ALAMEDA COUNTY
HEALTH CARE SERVICES

August 25, 2006

Subject: Fuel Leak Case No. RO0000260, Plaza Car Wash, 400 San Pablo Avenue, Albany, CA

Revised Figure 1

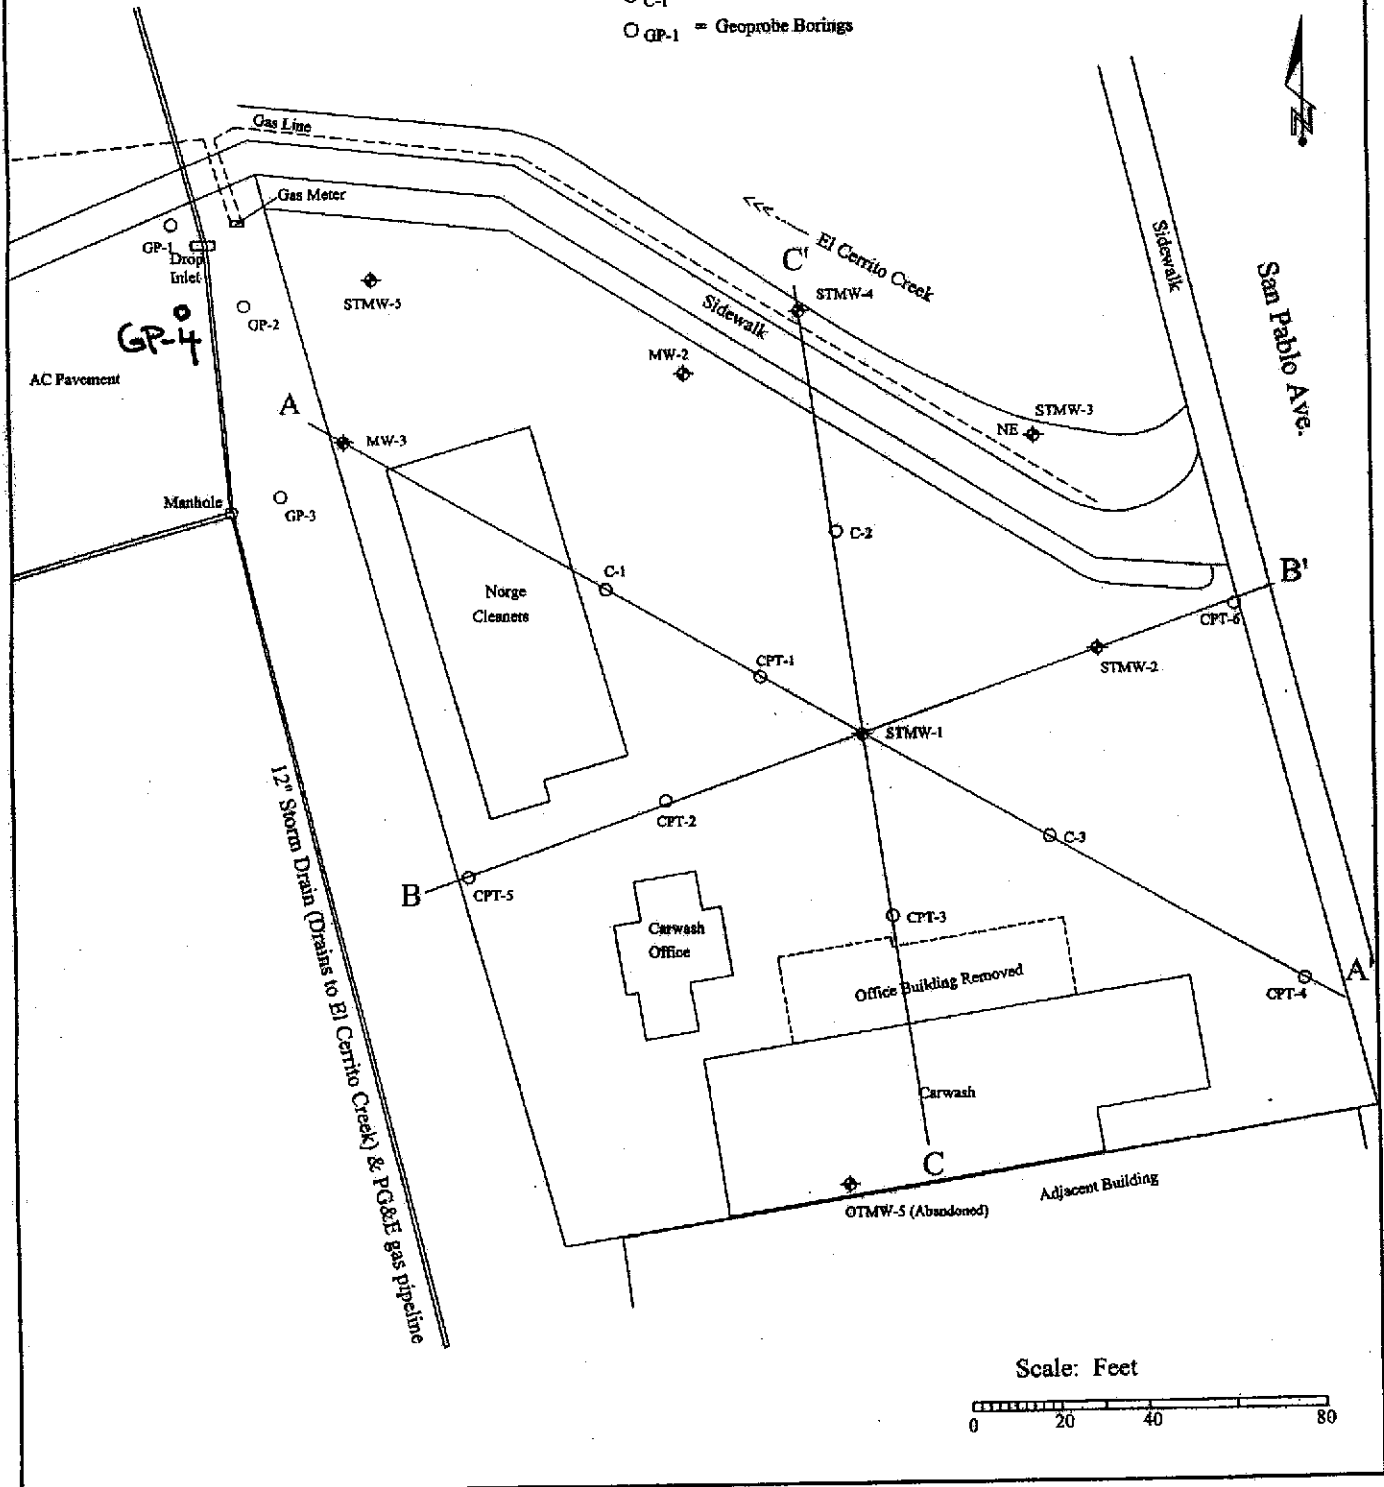
4. **Proposed Drilling Locations to Assess Storm Drain.** The three proposed soil boring locations in the area north of the manhole in Adams Street are acceptable. However, as discussed in technical comment 5 below, we request one additional soil boring on the west side of the storm drain. These direct push borings are to be advanced using the methods described in section 2.3.3 of the "Addendum to Previously Submitted Work Plan," dated April 12, 2006. The results are to be presented in the Soil and Groundwater Investigation Report requested below.

5. **Assessment of Groundwater Discharges to Storm Drain and Sampling of Adams Sump.** In our October 21, 2005 correspondence, we indicated that, "Contaminant transport to the storm drain is a significant pathway that must be considered. The current extent of contaminant discharges to the storm drain is a major data gap for this site that must be addressed." In our October 21, 2005 correspondence and during our meeting with you and Enviro Soil Tech at the site on June 6, 2006, we requested further information on past excavation and repair activities affecting the storm drain and maps showing the configuration of the storm drain and the repair activities. This information was not provided nor referenced in the Work Plan. Please present this information in the Soil and Groundwater Investigation Report requested below.

Attachment: Sump Location Plan with Recommended Soil Boring Locations

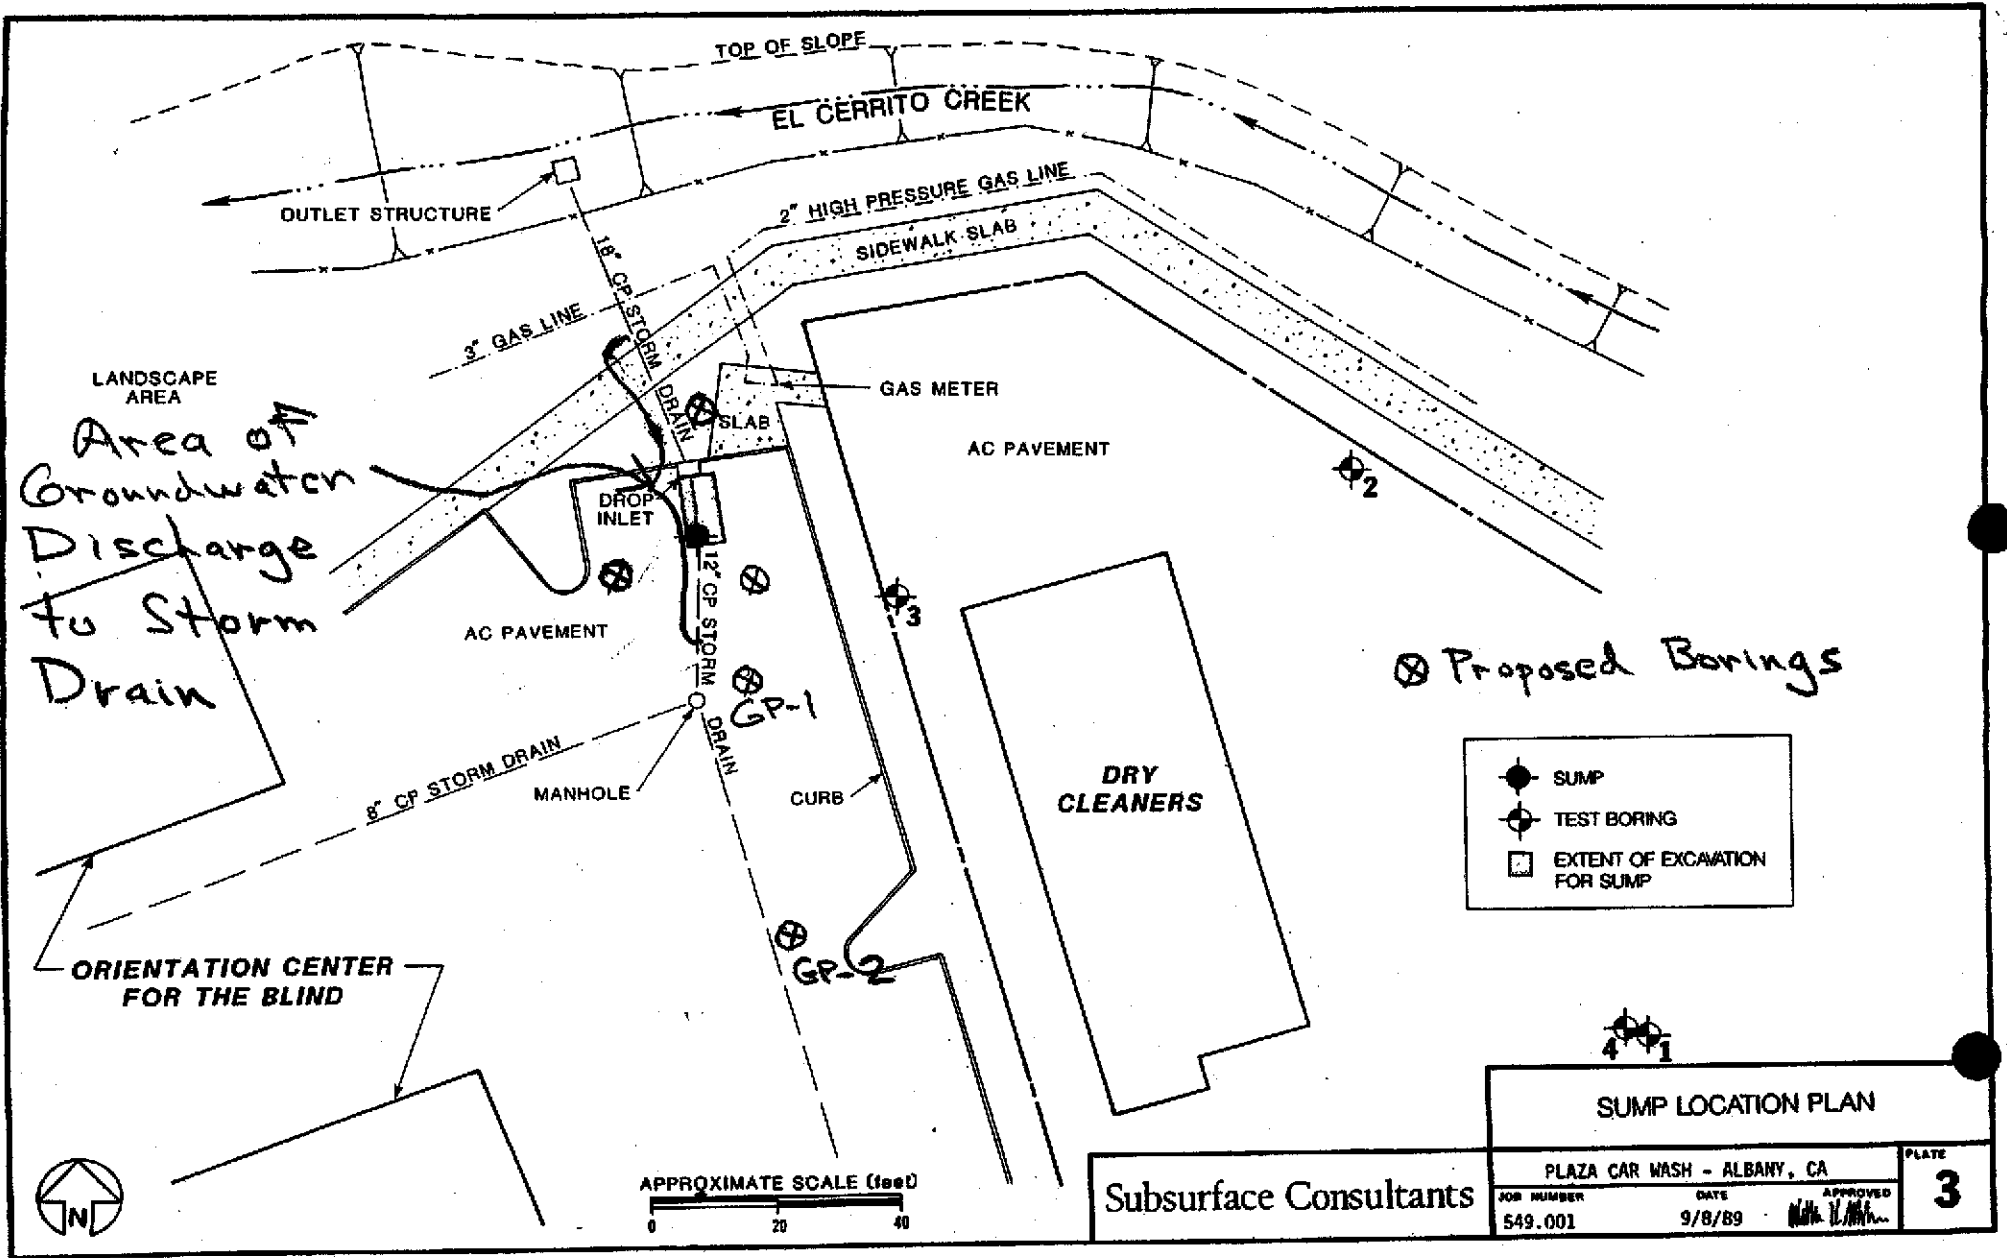
8. **Proposed Drilling Locations to Assess Storm Drain.** The Work Plan proposes five direct-push soil borings along a portion of the western boundary of the property. Previous investigations and reports describing repairs to the storm drain have shown that groundwater discharges to the storm drain occurred north of the manhole in Adams Street that is west of Norge Cleaners. Therefore, it is not clear why ESTC would only propose soil borings south of the manhole. The map entitled, "Proposed Wells," (Figure 1) presented in the Work Plan lacks detail and does not cover the area northwest of Norge Cleaners, where groundwater discharges to the storm drain are known to have occurred. Soil borings are required in the area northwest of Norge Cleaners. Please review relevant data and reports as discussed in technical comment 6 and revise the plan to assess the storm drain. A minimum of three additional soil borings is required in the area north of the manhole in Adams Street. The attached Plate 3 presents three recommended boring locations in this area. In the revised Work Plan requested below, you are to use the reports referenced in technical comment 6 to prepare a detailed base map showing the storm drain, sump, previous sampling locations, proposed sampling locations, and other features related to the storm drain along the western boundary of the property and the area northwest of Norge Cleaners. Please present the base map and your plans to assess groundwater discharges to the storm drain in the revised Work Plan requested below.

proposed investigation and during future groundwater monitoring. Please include plans to sample the sump in the revised Work Plan requested below.
